**October 13, 2021
7:00 PM
Planning Board Agenda**

Re: **Response to Lanc & Tully Comments dated 09/08/21 and John Clarke comments dated 09/09/21**
*248 Beacon Holdings LLC - Fishkill Creek Development Amended Site Plan for 248 Tioronda Avenue
(Formerly Beacon 248 Development, LLC, Multifamily Development)
248 Tioronda Avenue, City of Beacon, Dutchess County, NY
Chazen Project #81750.00*

Re: Supplemental Submission – Application for Amended Site Plan Approval
Modification to Approved Greenway Trail
Premises: 23-28 Creek Drive, Beacon, New York
Tax Parcel ID: (6054-37-037625)

1 BASEMENT PLAN
1/8" = 1'-0"

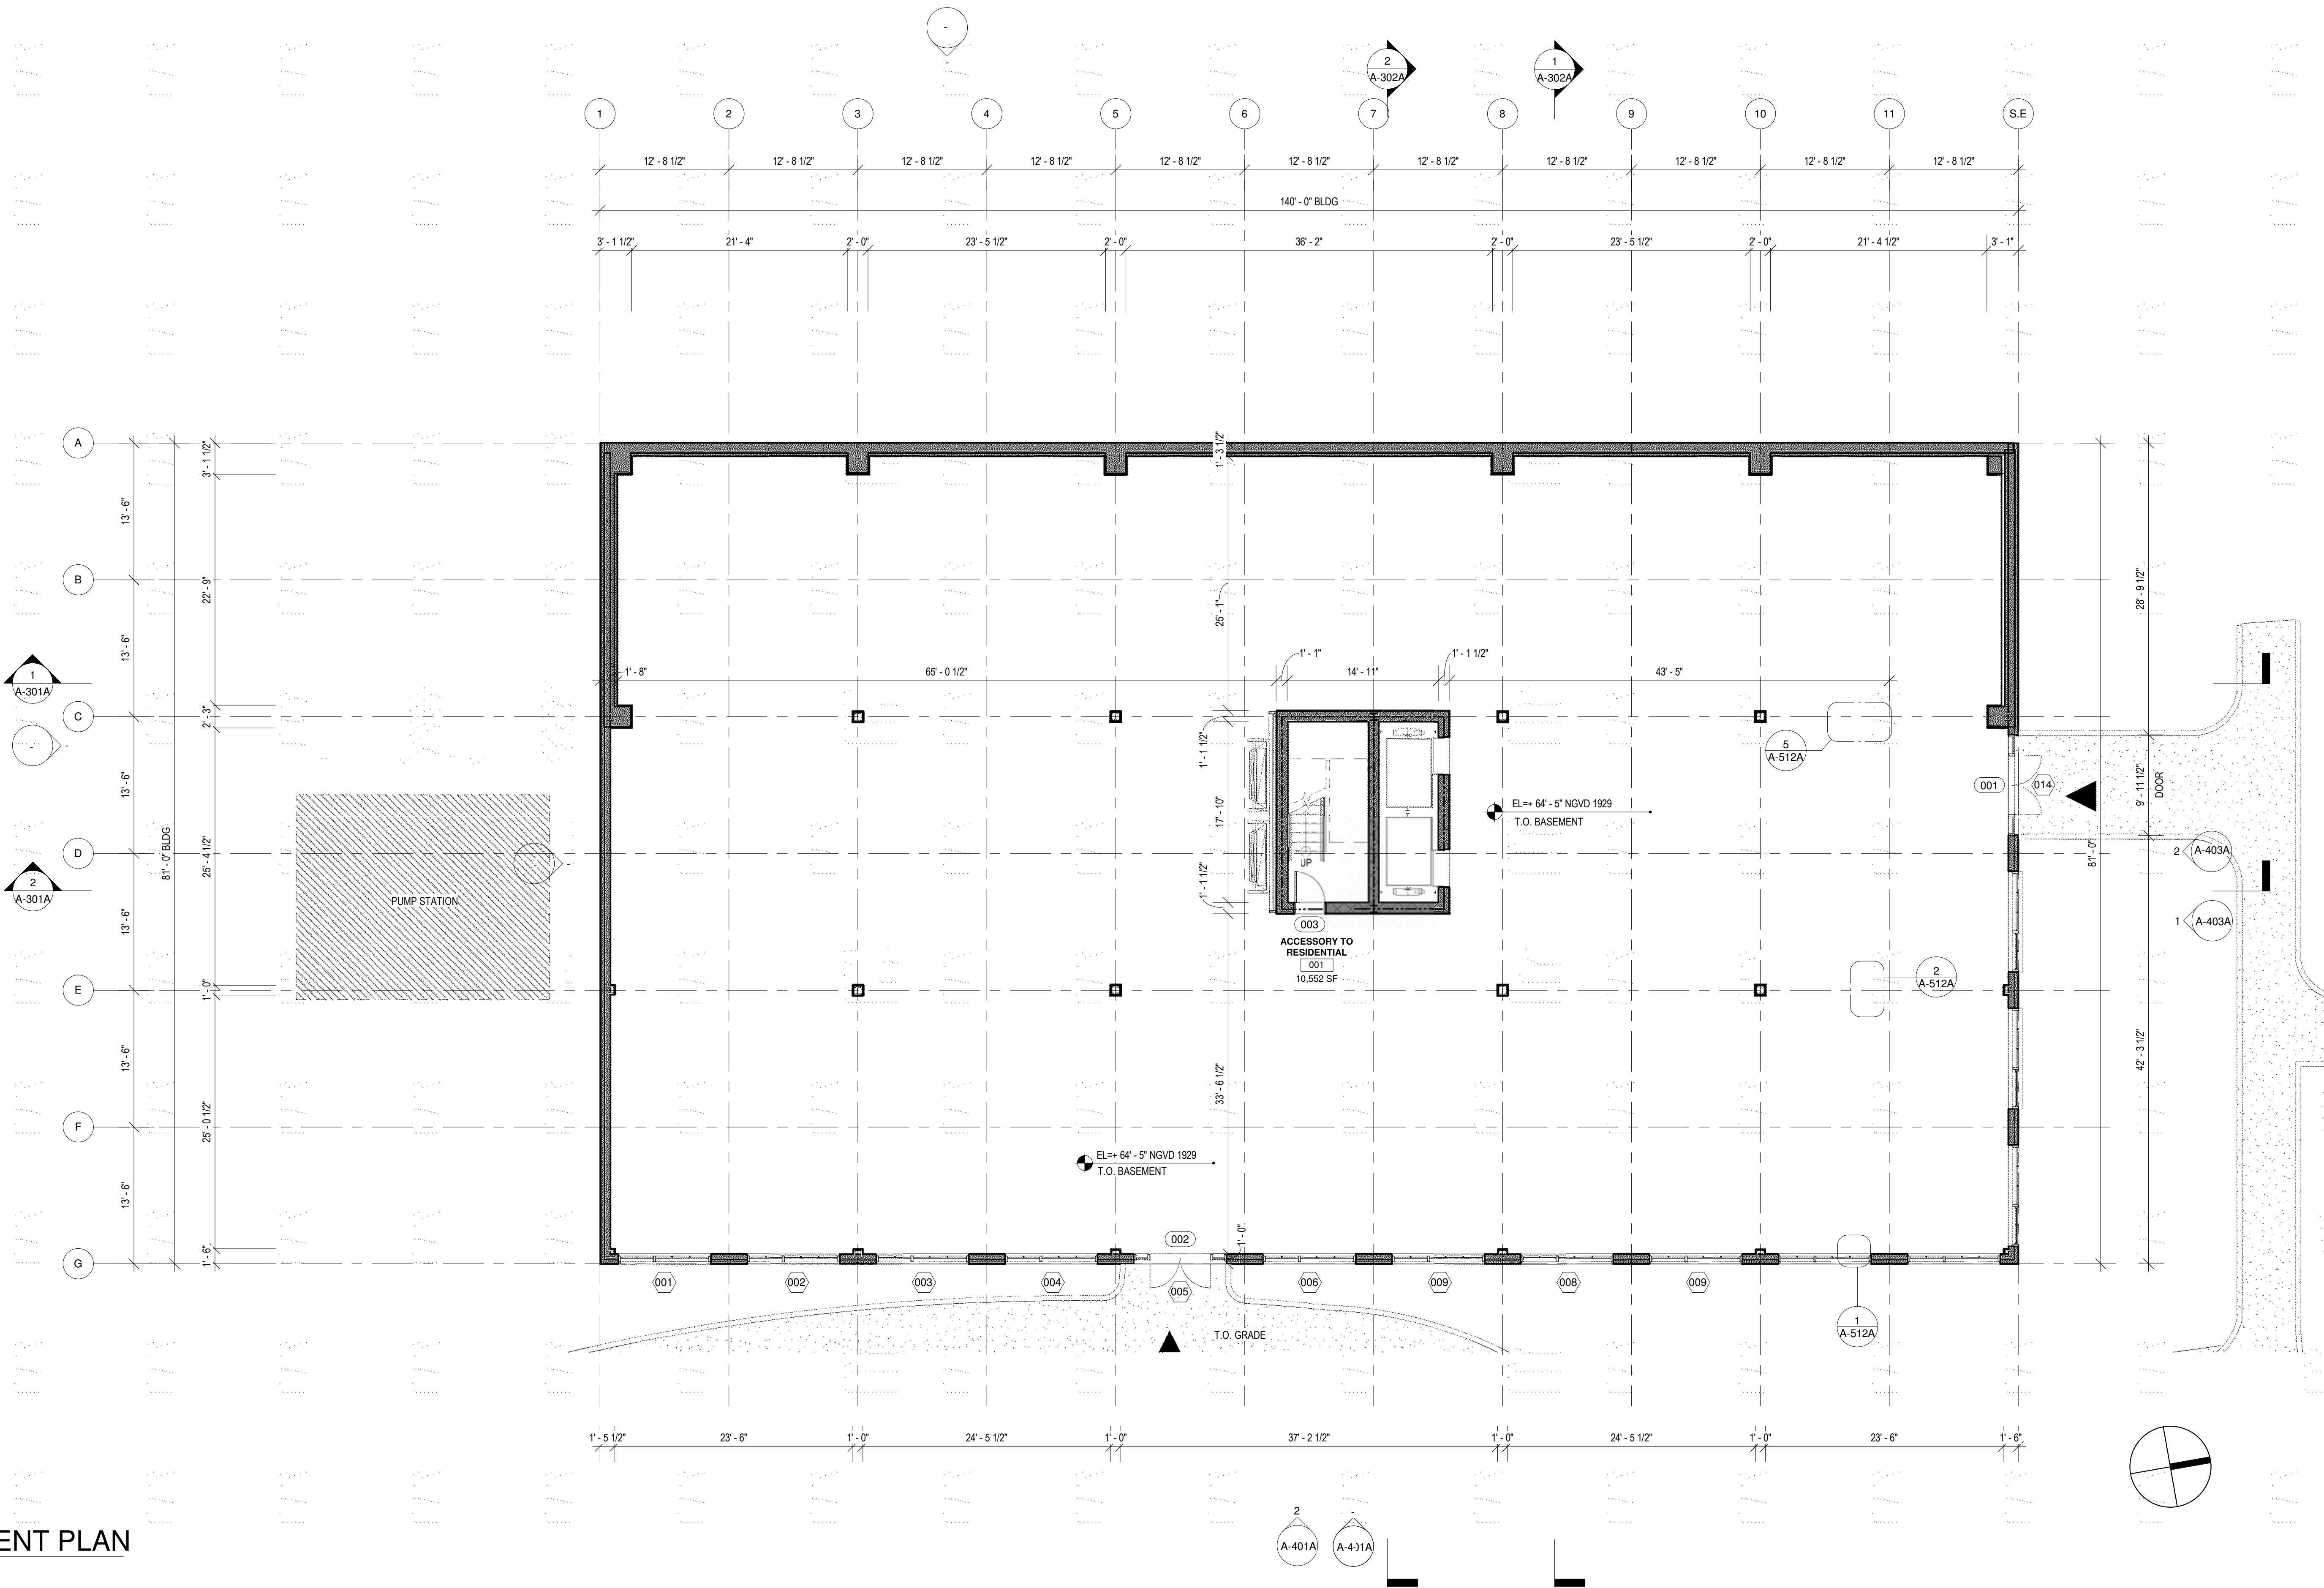
- a. The applicant has stated that the Building 100 basement level would be used for residential support uses, such as a gym, storage, and other uses that would not affect the overall parking count. Therefore, the Basement Plan should not be labeled as commercial space.

Response: Plan will be revised, label shall state "Accessory Residential"

1 ELEVATION - NORTH 01
1/8" = 1'-0"

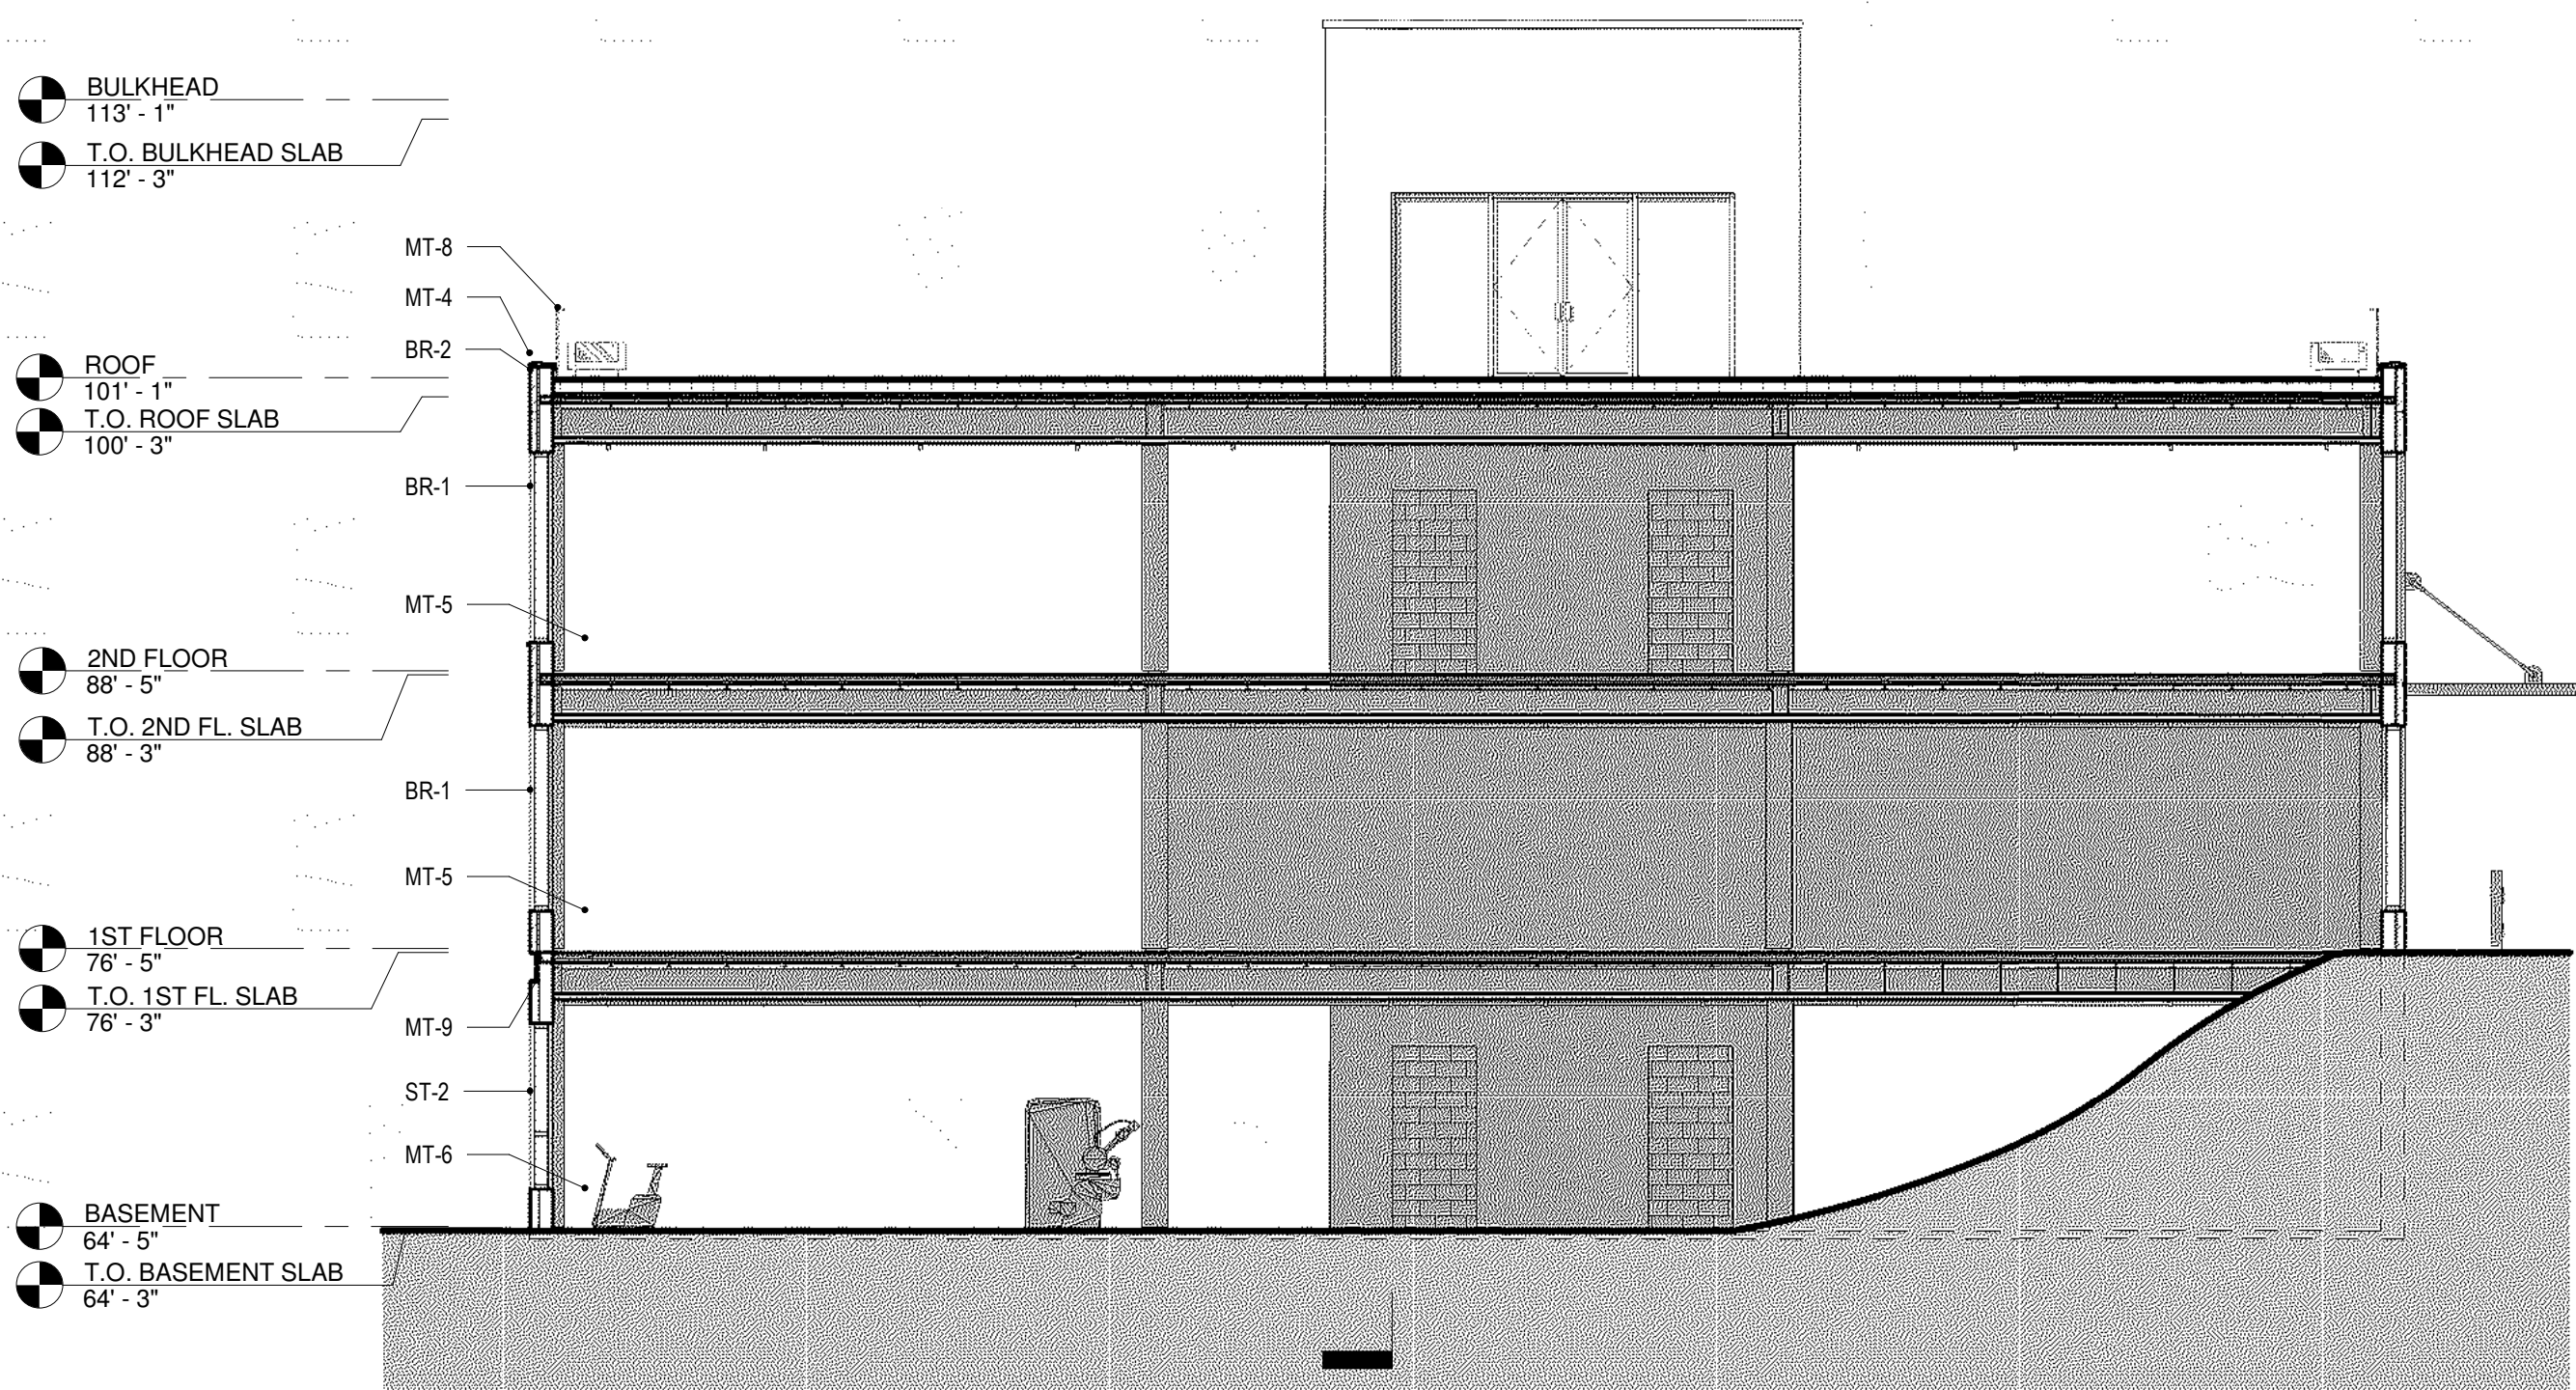
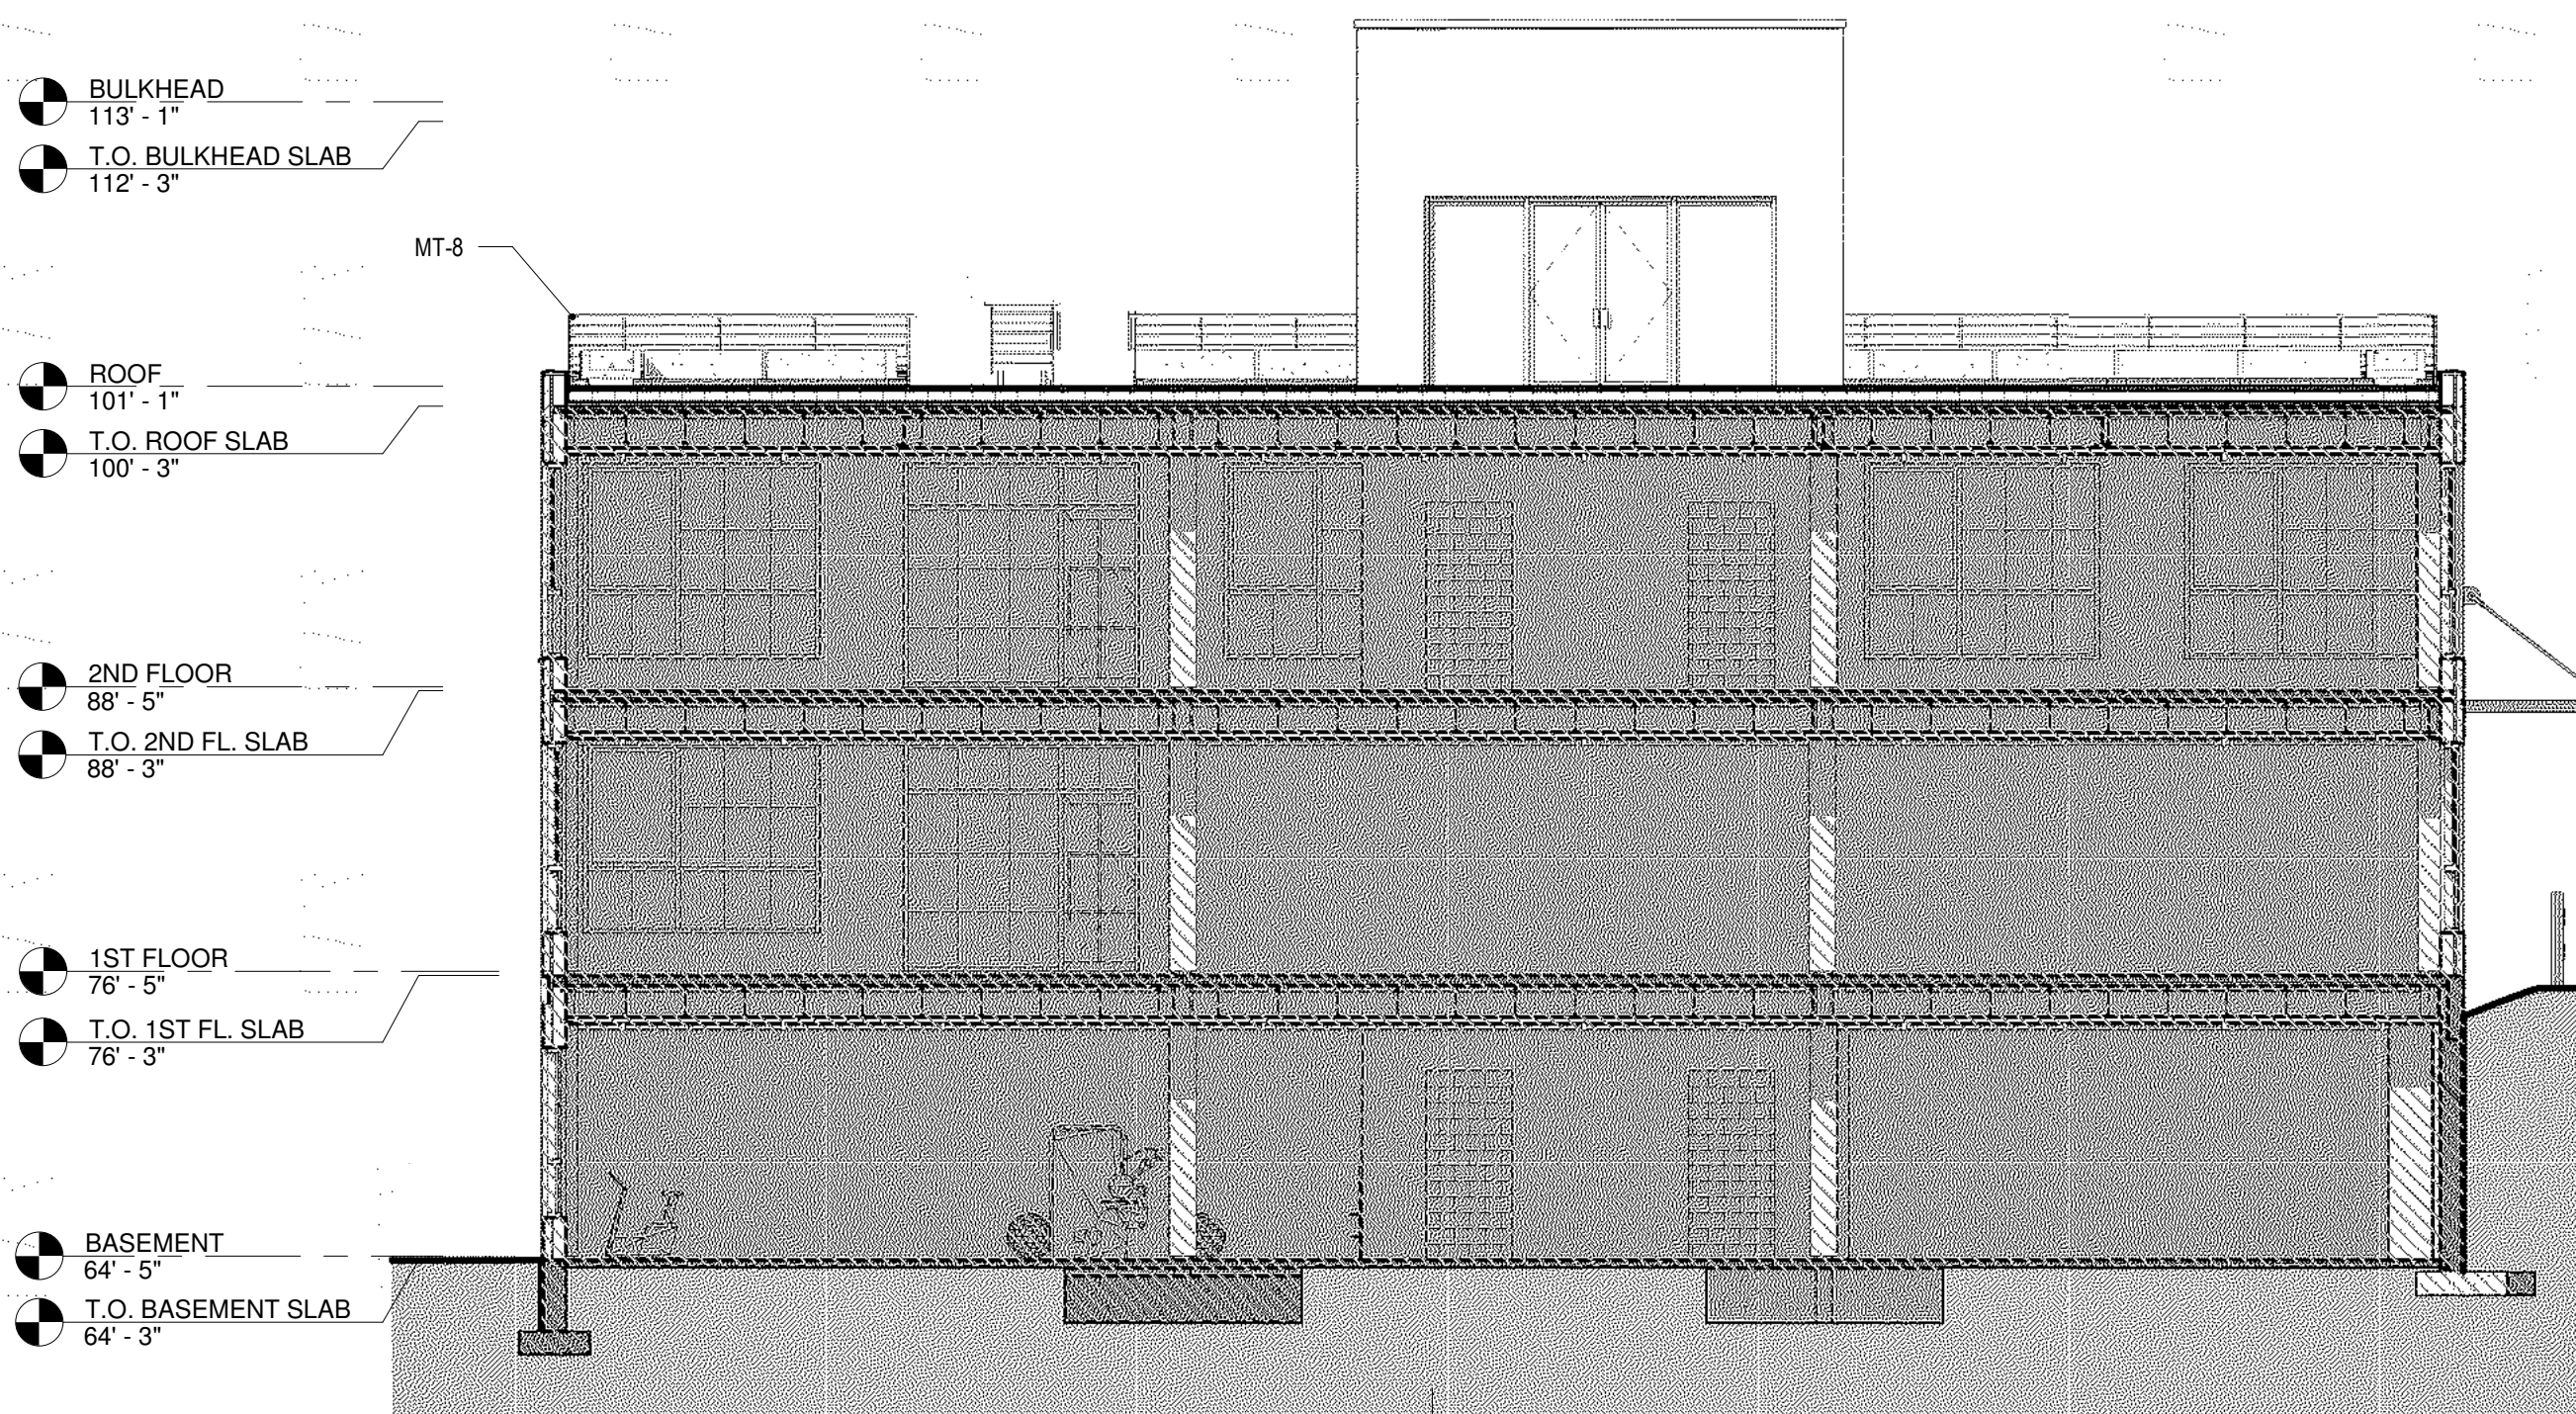
- c. The exterior materials and colors should be labeled on the elevation plans. The type of brick, thin or full-size, should be indicated, the roof railing should have a detail, and there should be a legend explaining all the material abbreviations.

Response: Material legend sheet and roof railing sheet shall be added to submission.
